Subject: River Bend Station – Unit 1
Docket No. 50-458
License No. NFP-47
Submittal of Revisions to Emergency Implementing Procedures

**LIST OF REVISED
EMERGENCY IMPLEMENTING PROCEDURES**

PROCEDURE NAME	TITLE	CURRENT REV.
EIP-2-002	Classification Actions	21
EIP-2-007	Protective Action Recommendation Guidelines	18
EIP-2-018	Technical Support Center	22
EIP-2-103	Emergency Equipment Inventory	16

PAR PROCESS

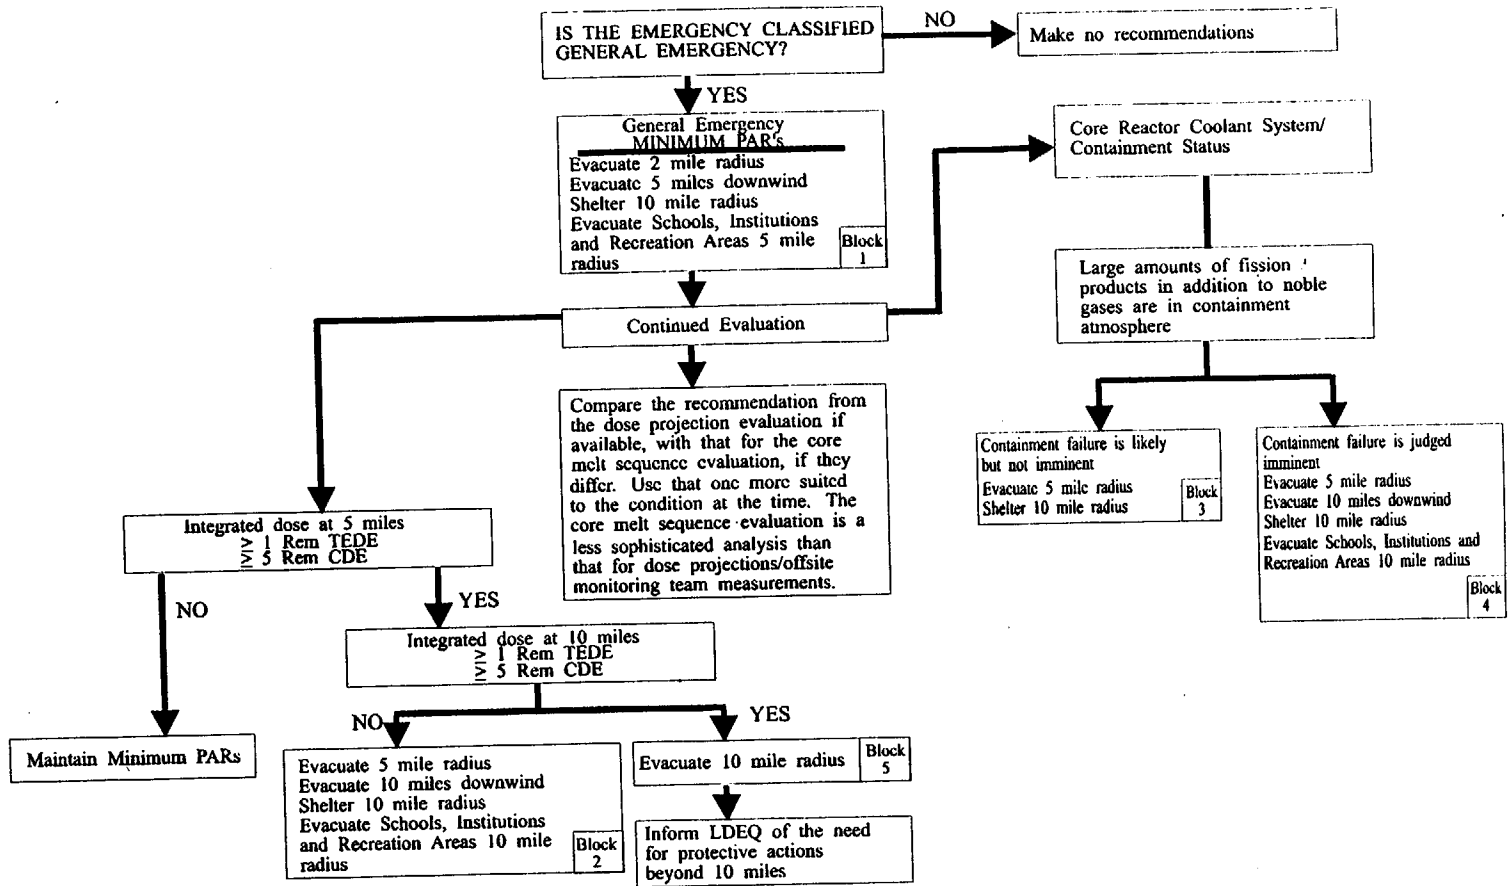
9. Steps 6.1.3 through 6.1.8- This information has been converted into the flowchart steps of Attachment 1. Additionally, specific details of contacting the local authorities within 5 minutes, etc. are contained in the Control Room Communicator's checklist in EIP-2-006 Notifications.
10. Step 6.1.9- Reworded text to state wind shifts which change the "scenario number may" trigger an increase in PARs to a higher level. "To determine the appropriate PAR, review the emergency scenario maps and the National Weather Service (NWS) forecast. In addition, if NWS indicates continued wind shifts" consider the following guidance...
11. Added Attachment 1 PAR Process.
12. Attachment 2- Changed LRPD to LDEQ due to their name change.
